Date Filed: April 14, 2023

Request from: Connecticut Siting Council

Question: 1

Existing bridge with transmission facilities currently attached.

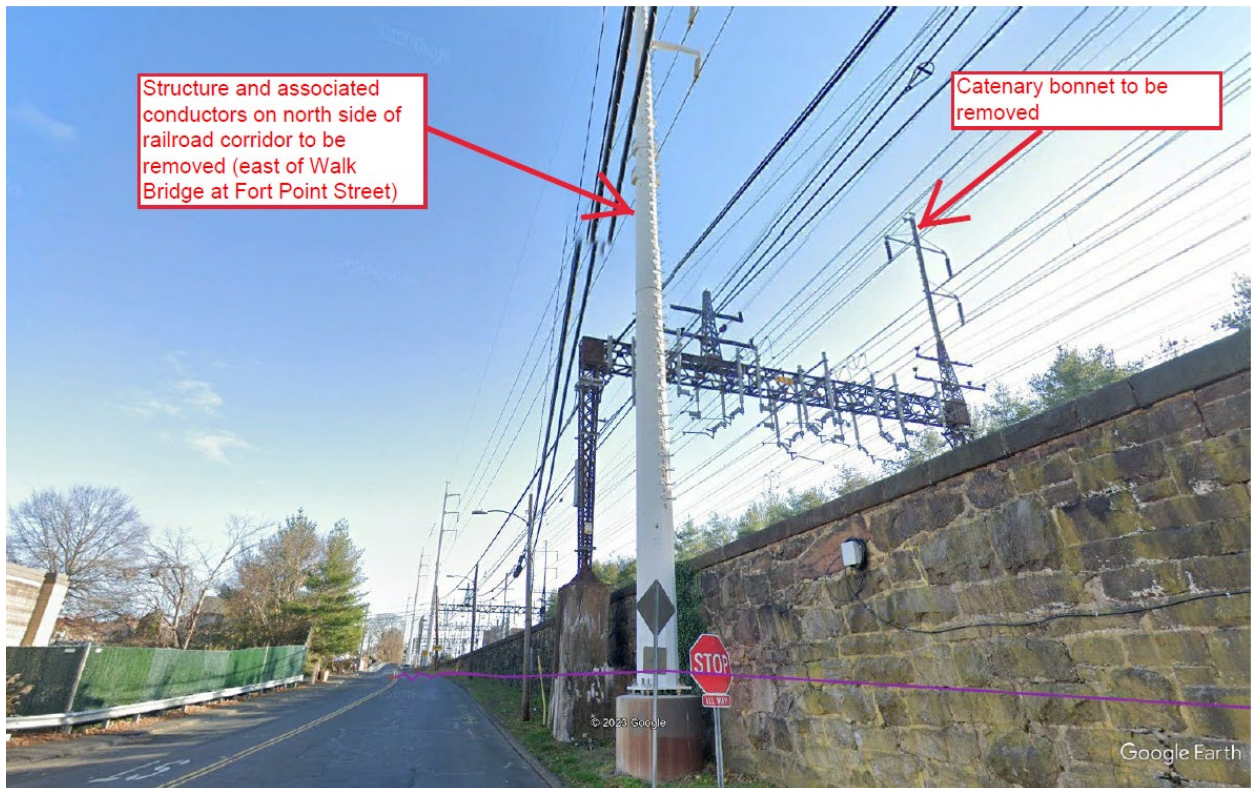
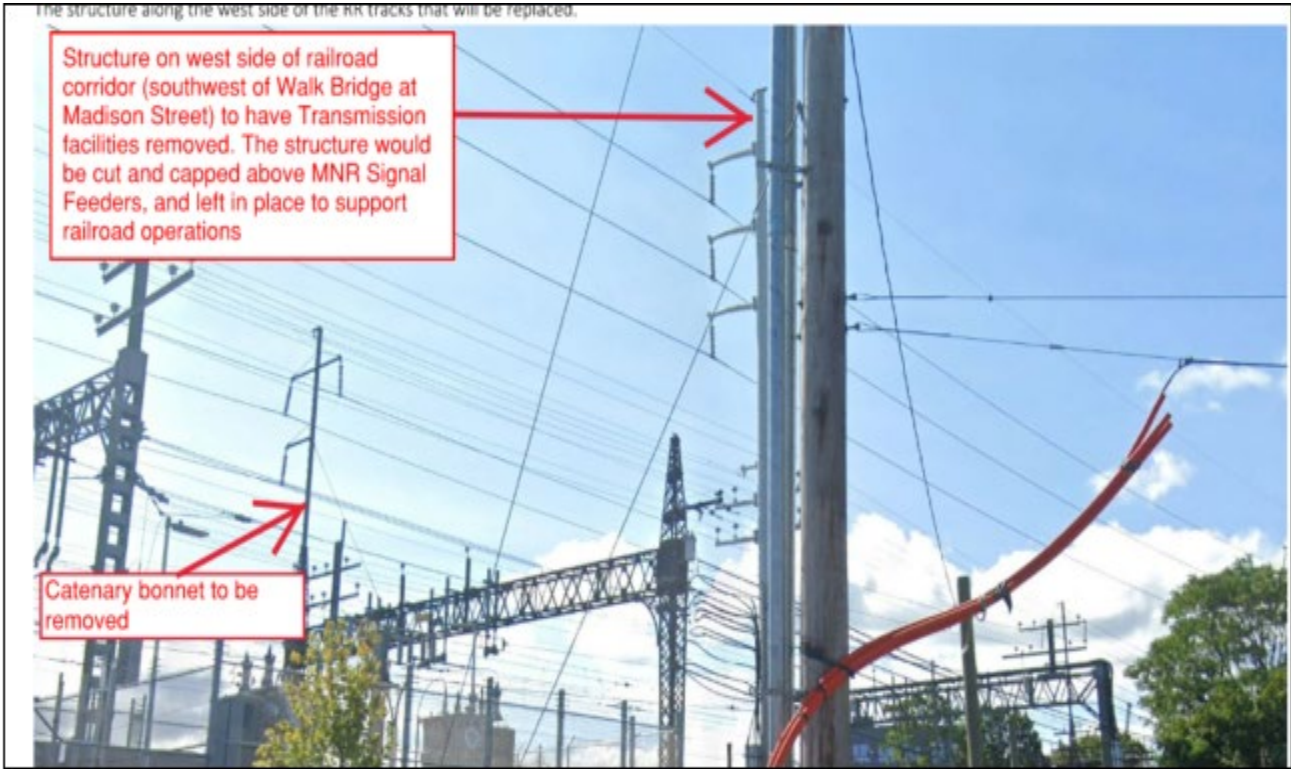
Provide photographs of:

- a. the existing transmission facilities to be removed; and
- b. the existing bridge with transmission facilities currently attached

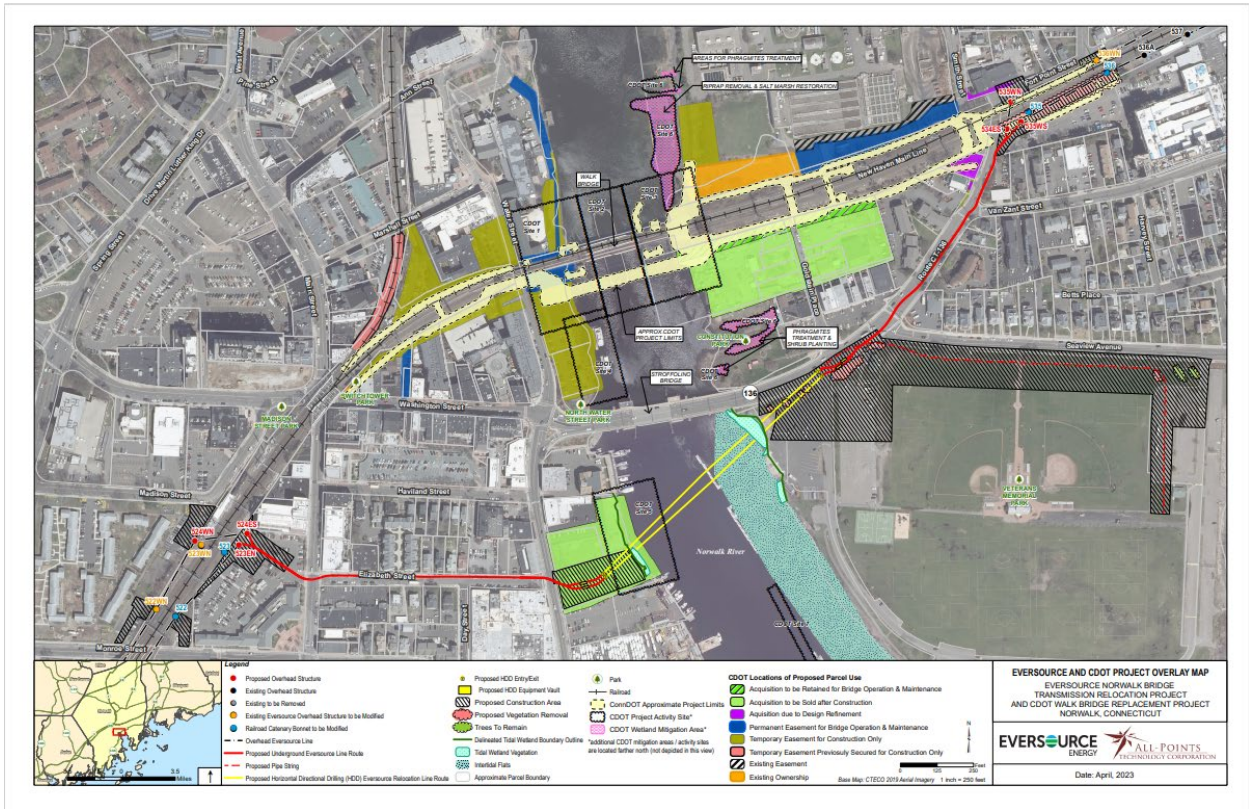
Referencing Figure A-2, Proposed Route Map, on page A-8 of the Petition and the maps for the CDOT Norwalk Bridge Replacement project in the Finding of No Significant Environmental Impact, dated April 28, 2022, available at:

<https://www.walkbridgect.com/pdf/walk%20bridge%20fra%20signed%20fonsi.pdf>, and attached, provide an aerial map that overlays the CDOT maps and depicts the following **for both projects**:

- a. Project limits (CDOT Figures 1 and 2);
 - b. Mitigation areas (CDOT Figure 3);
 - c. Parcel use locations (CDOT Figure 4);
- Project activity locations (CDOT Figure 7)

Please see the aerial map (below and attached) that overlays the CDOT maps and depicts the following for the CDOT's Norwalk Bridge Replacement Project and Eversource's transmission line relocation project:

- a. Project limits;
- b. Mitigation areas;
- c. Parcel use locations;
- d. Project activity locations

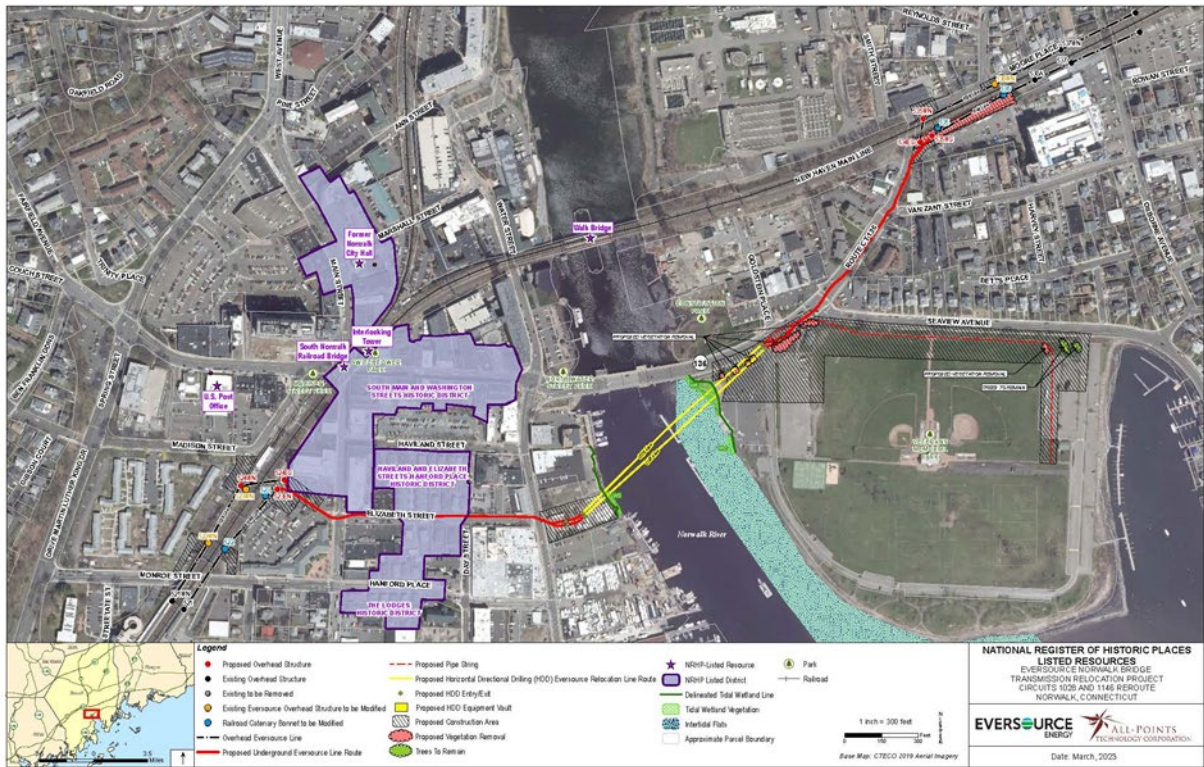
Provide an aerial map that overlays the below CDOT Area of Potential Effect Map for the Norwalk Bridge Replacement project and depicts all above-ground NRHP-listed sites proximate to Eversource's transmission facility replacement project area. Provide the addresses or approximate street boundaries of each.

A map depicting above-ground NRHP-listed sites proximate to Eversource's project area is provided below. Two abutting NRHP-listed historic districts are in proximity to the project, including: the South Main and Washington Streets Historic District and the Haviland and Elizabeth Streets Historic District.

The South Main and Washington Streets Historic District is bounded by the railroad corridor on the west, Monroe Street and Elizabeth Street to the south, South Main Street, and extending east south and north of Washington Street (incorporating portions of properties/buildings on either side).

The Haviland and Elizabeth Streets Historic District is bounded on the north by Haviland Street, on the east by Day Street, on the west by South Main Street, and on the south by properties facing Hanford Place.

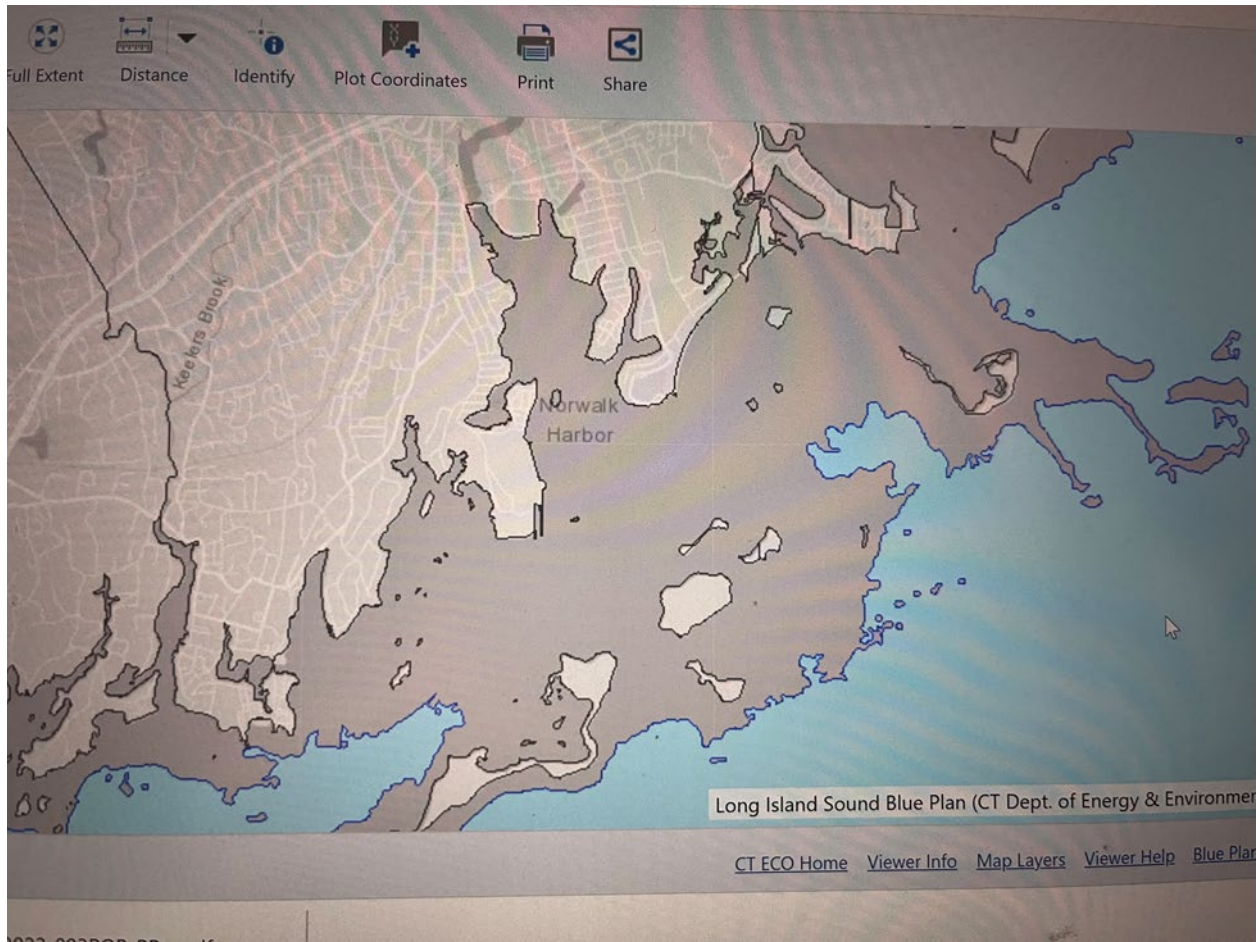
Is the project located within the policy area of the Long Island Sound Blue Plan? If so, how would the project comply with its policy objectives? Are any Ecologically Sensitive Areas or resources identified by the Blue Plan within the project area?

Based on a review of the Connecticut Environmental Conditions Online Blue Plan viewer, Eversource's project area is not located within the policy area of the Long Island Sound Blue Plan (see screen shot below). The blue shading represents the Blue Plan policy boundary area, which is well offshore from Eversource's project location.

No Ecologically Significant Areas identified by the Blue Plan are located within the Project area. Potential Significant Human Use Areas are proximate to the Project area, as this category includes, among others, waterfront historic districts, anchorage areas, marinas, designated navigational channels, and transmission facilities within the Blue Plan Area of Interest.
